The Commission has issued the enclosed Amendment Nos. 69, 65 and 41 to Facility License Nos. DPR-33, DPR-52 and DPR-68, respectively, for the Browns Ferry Nuclear Plant, Units Nos. 1, 2 and 3. These amendments consist of changes to the Appendix B Environmental Technical Specifications in response to your request dated August 29, 1979 (TVA BFNP TS 130).

BROWNS FERRY NUCLEAR PLANT, UNIT NO. 1

AMENDMENT TO FACILITY OPERATING LICENSE

Amendment No. 69  
License No. DPR-33

BROWNS FERRY NUCLEAR PLANT  
TVA Office of Power  
Organization for Operation  
of Nuclear Plants  
Figure 5.2-1

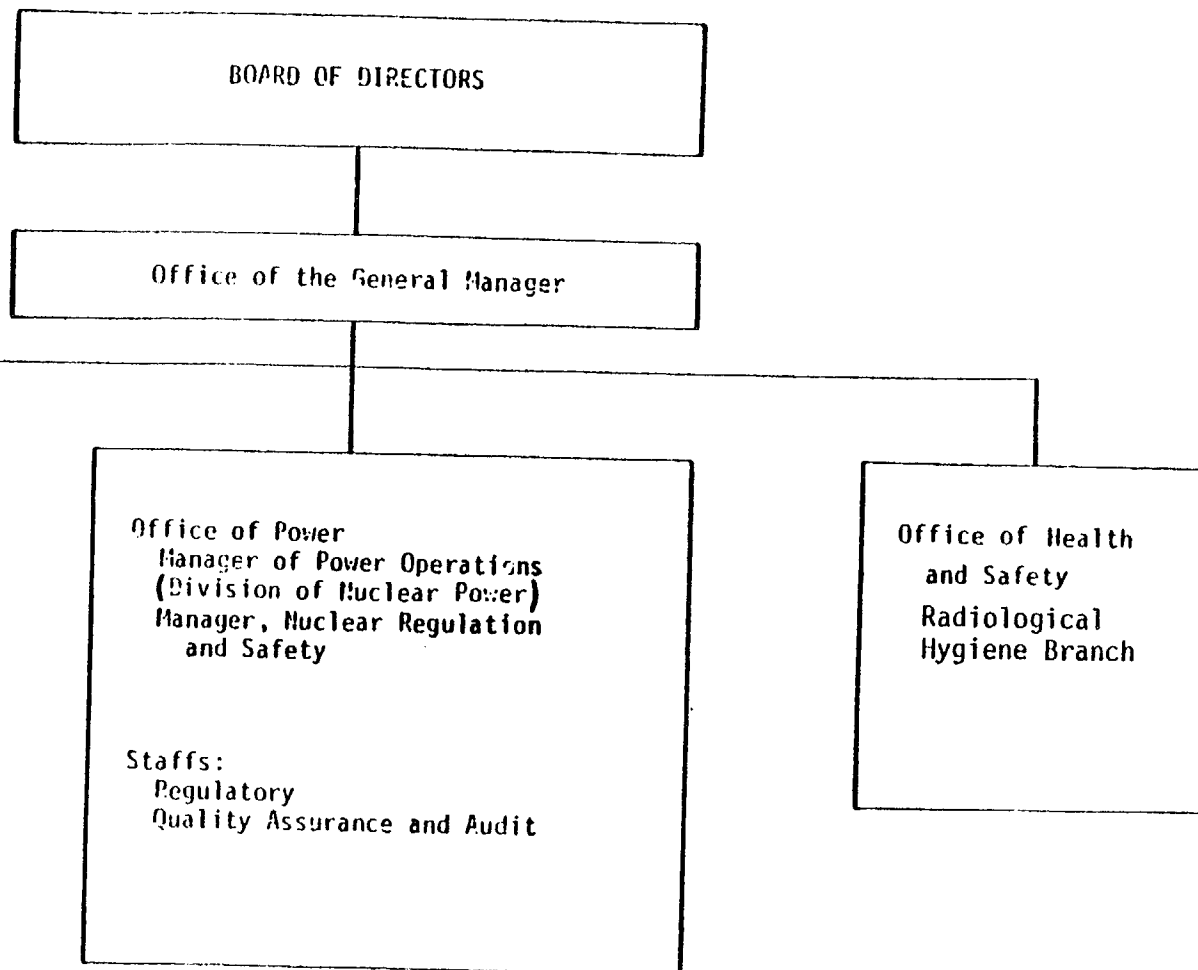
These amendments revise the Environmental Technical Specifications to: (1) delete section 2.1 which presently specifies limiting conditions of operation (LCO) on thermal discharge limits, (2) delete section 2.2 which specifies LCOs for chemical discharges to the aquatic environment, (3) delete section 3.1.2 which describes the expected maximum concentrations of chemicals of the plant effluents before and after mixing in the river, (4) delete Section 5.4 which specifies actions to be taken if a water quality LCO is exceeded, (5) delete section 5.6.3.b which specifies reporting requirements when an LCO on water quality is exceeded, (6) delete item 5.7.1.C which specifies the records and logs to be maintained on LCO violations of water quality and (7) change the titles in section 5.0 (Administrative Controls) of the offices within TVA responsible for environmental activities.

Administrative Controls to change the titles and organizational elements within TVA responsible for environmental activities is being made to reflect recent organizational changes within TVA.

- 5.2.1 The organization of TVA management which directly relates to operation of the plant is shown on Figure 5.2-1.
- 5.2.2 The principal organizations within TVA which are concerned with environmental matters related to nuclear power plant operations are the Office of Power, Office of Natural Resources, and the Office of Health and Safety. The Office of Power is directly responsible for operating the plant in accordance with specified requirements and conducting onsite monitoring. The Office of Natural Resources and the Office of Health and Safety are responsible for providing technical guidance, assistance, monitoring, and other services as needed for environmental compliance. The Environmental Compliance Staff is responsible for independent review and audit of procedures for meeting environmental specifications and limits. The organizations above report to the General Manager as shown in Figure 5.2.2.
